Project Number: 1474

**Subject: Barrhaven Conservancy West - Hydraulic Impact Assessment**

This Memo is related to the Barrhaven Conservancy West lands and specifically addresses comments received as part of the Barrhaven Conservancy West Draft Plan circulation, notably, comments 4.5 and 4.6 prepared by the RVCA.

TITLE :  
 Figure 1-1  
 Peak Water Level Difference:  
 2D RVCA Proposed Abeyance Lands (v22.2) - 2D 2019  
 Approved Development (v22.1)  
 (100 Year Flow - 196 cms)

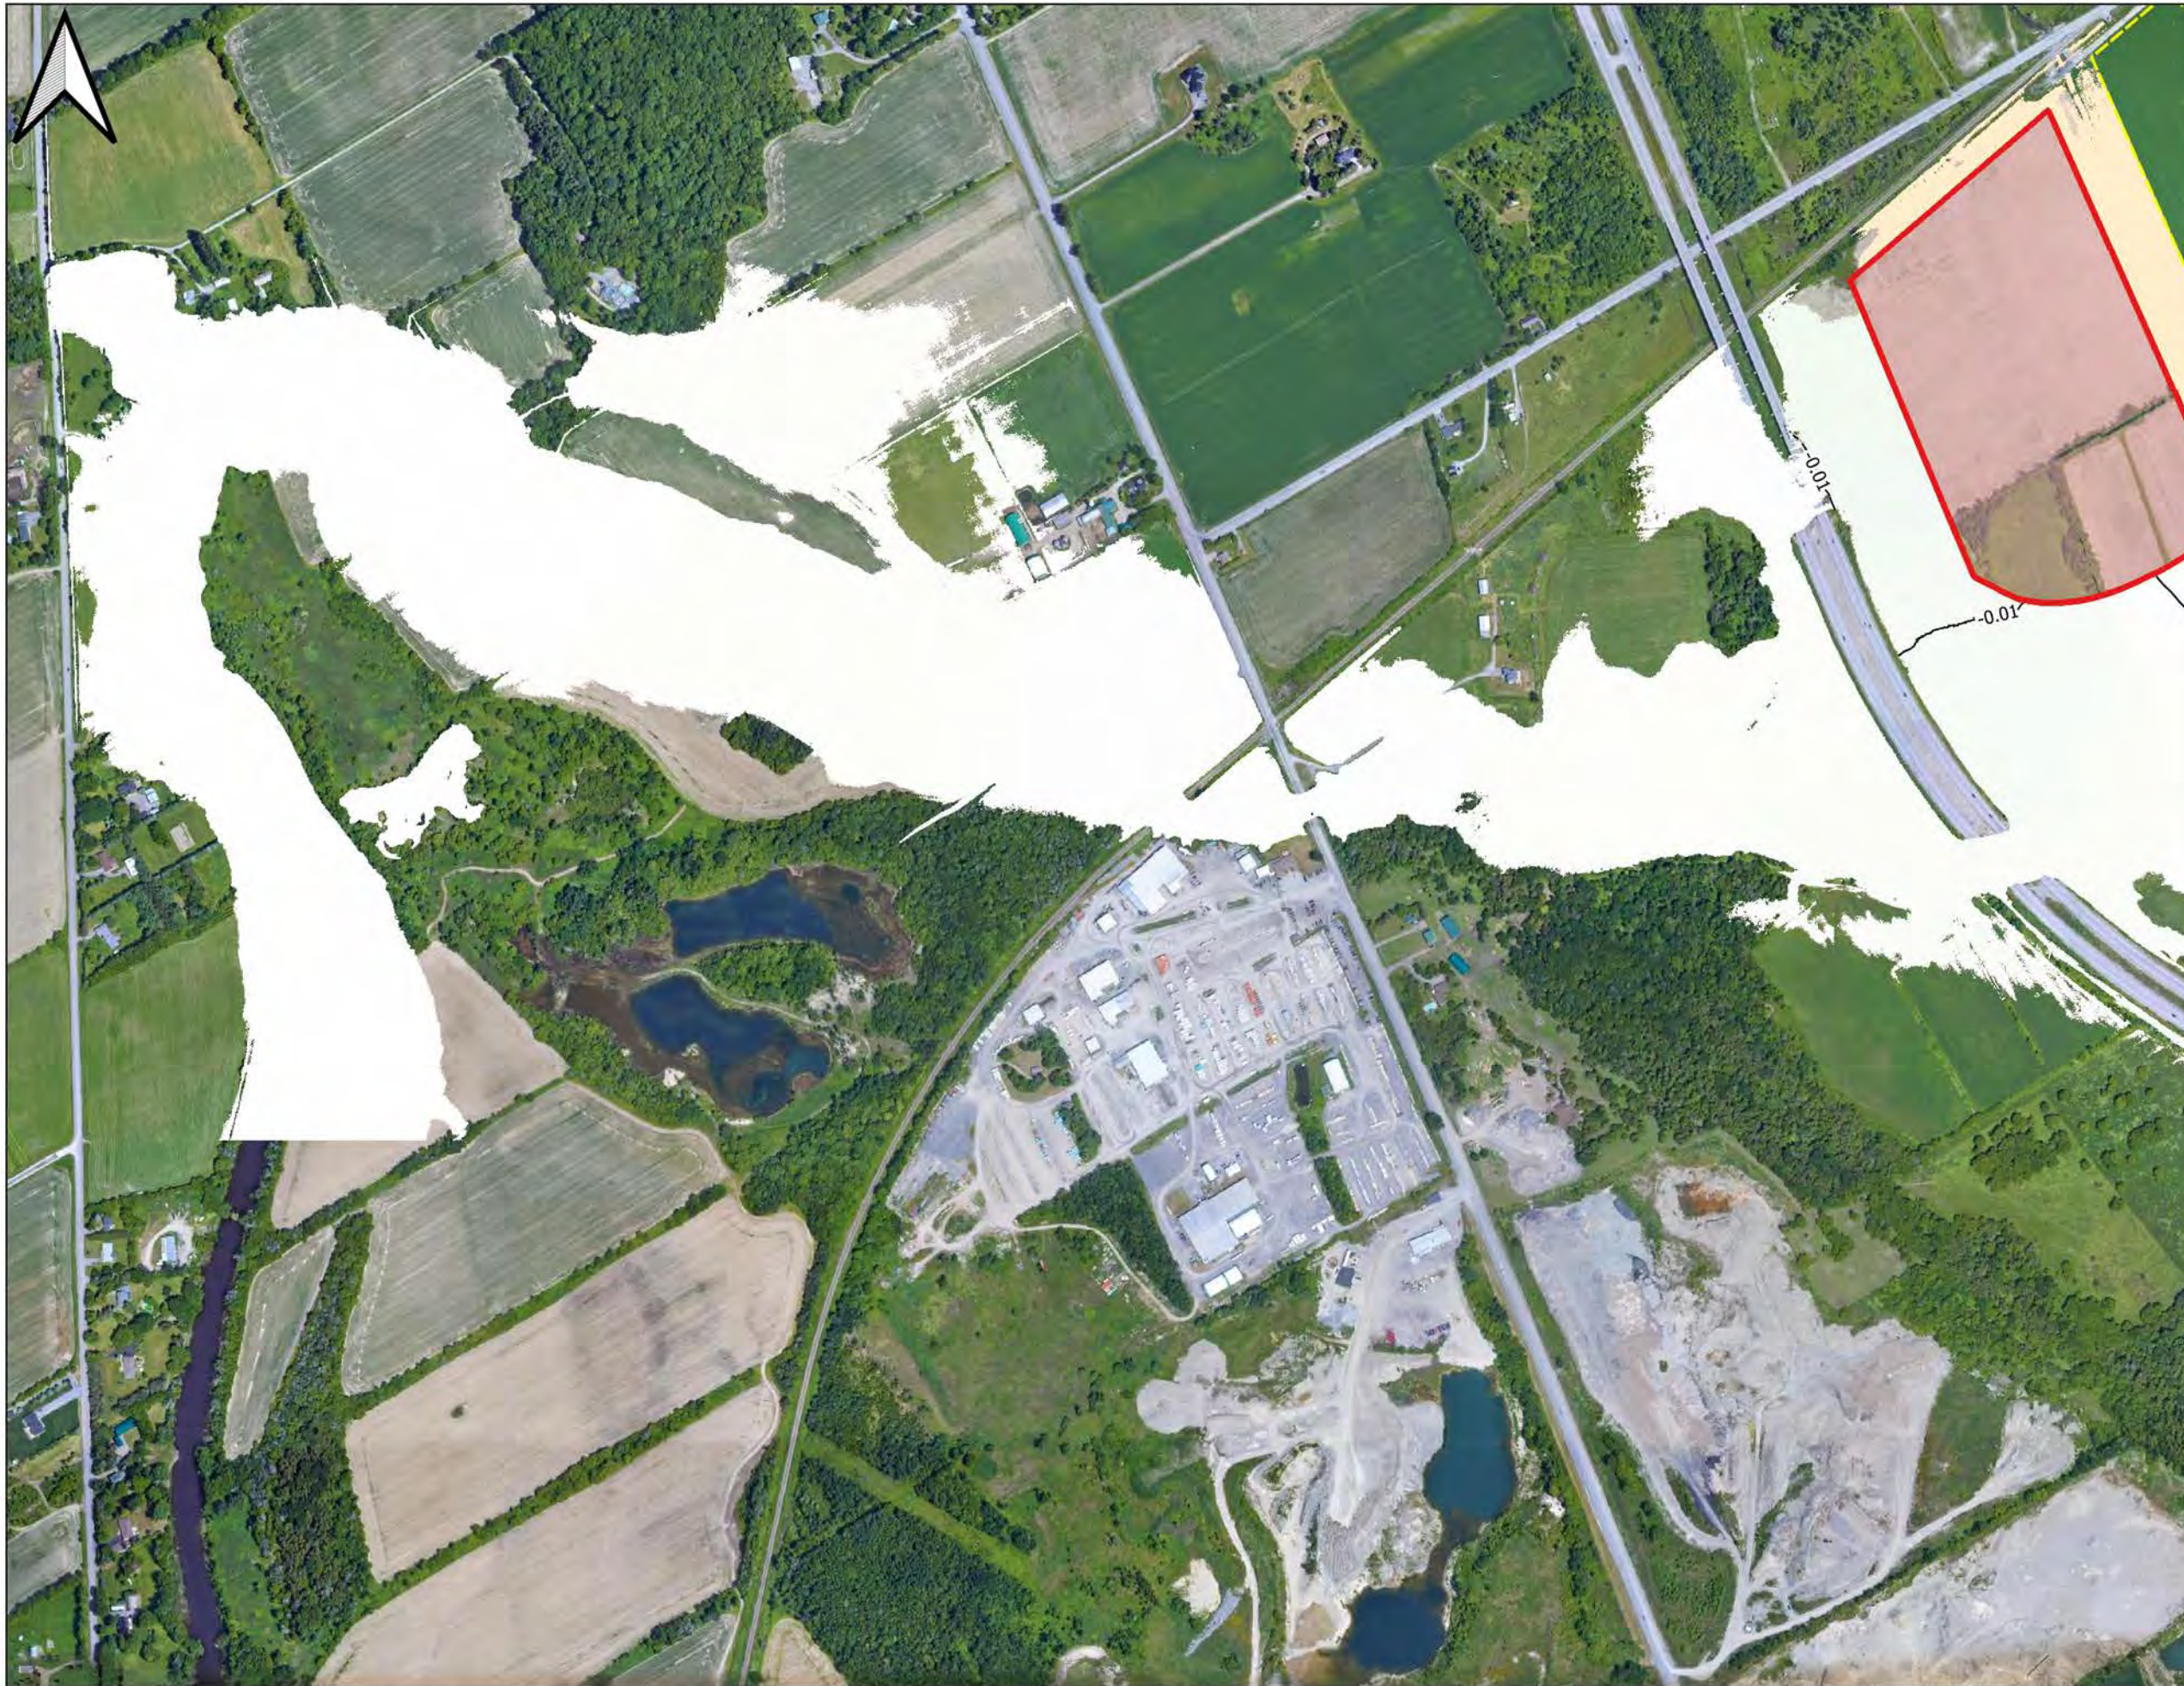
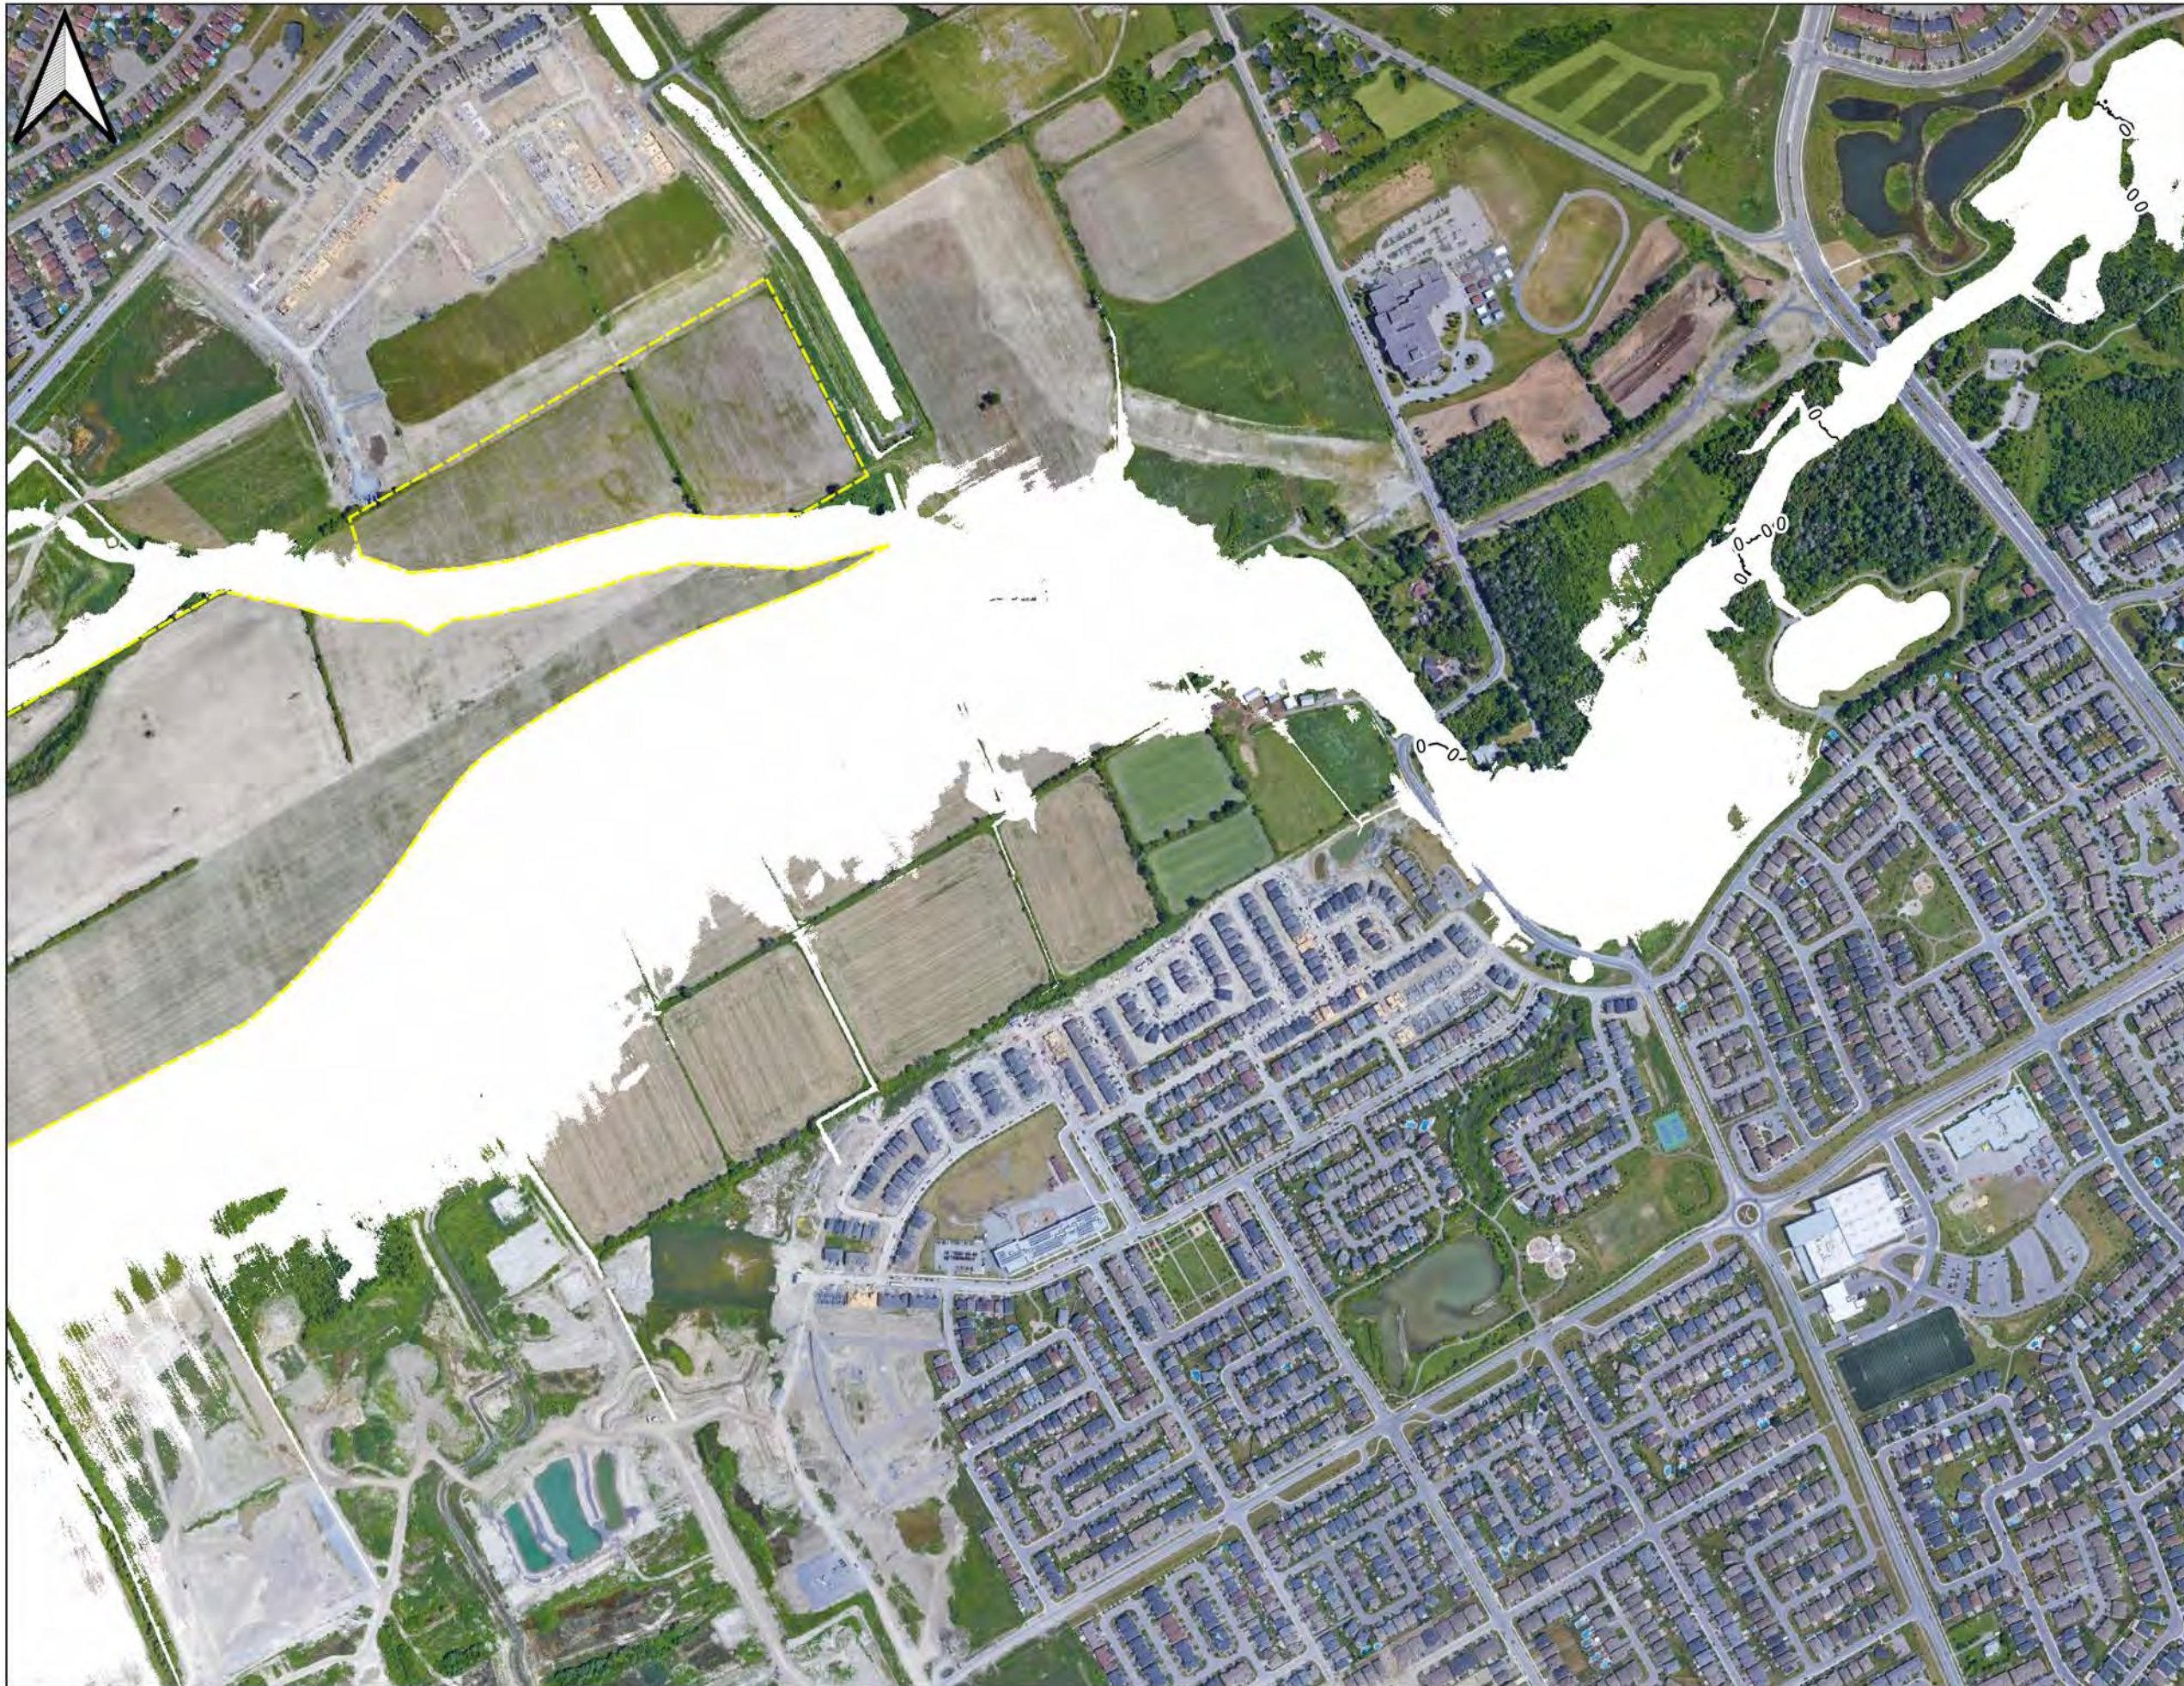
*4.5. Further, as part of the RVCA letter of permission (RV5-4419) for flood plain modifications, a monitoring program has been initiated as a condition of approval. As part of the monitoring program, it has been anticipated by the Conservation Authority that portions of the proposed subdivision are to be held from development as a potential area for modification should the monitoring program identify a need for additional cut be required. Portions of the lands west of the current O'Keefe alignment were identified as being the optimal location to provide additional cut should it be required. As such, development of these lands should be held in abeyance, until the monitoring program has been completed and that an additional cut is demonstrated to not be required. [emphasis added]*

*4.6. As such, both concerns related to the extent of the proposed subdivision along with on-going monitoring and potential mitigation needs, the application is considered premature from a natural hazards perspective.*

**Figures 1-1 to 1-4** provide flood plain difference maps for the 100-Year flood comparing:

The difference maps have been produced by subtracting the peak computed water levels of approved 2019/2020 2D conditions from the 2D RVCA potential mitigating conditions. To illustrate the results, increases and decreases in the flood plain peak water level differences have been represented in light red (increases) and light blue (decreases), respectively. Water surface difference contours have been overlaid on this figure at 1 cm increments to provide context to the applied raster palette.

This analysis demonstrates that the lands proposed by the RVCA to be held in abeyance have a very limited impact on the water levels of the Jock River, with a localized **1 cm** decrease upstream of these lands when compared with the approved condition. There is also a localized increase of **2 cm** near the O’Keefe Drain, which is due to flows from the Jock River being able to flow directly to this location (which was previously protected by the filled parcel). As indicated in this figure, the lands proposed by the RVCA to be held in abeyance have a very limited mitigating effect on peak water levels on the Jock River when compared to the expected results presented in the JFSA October 2019 report.
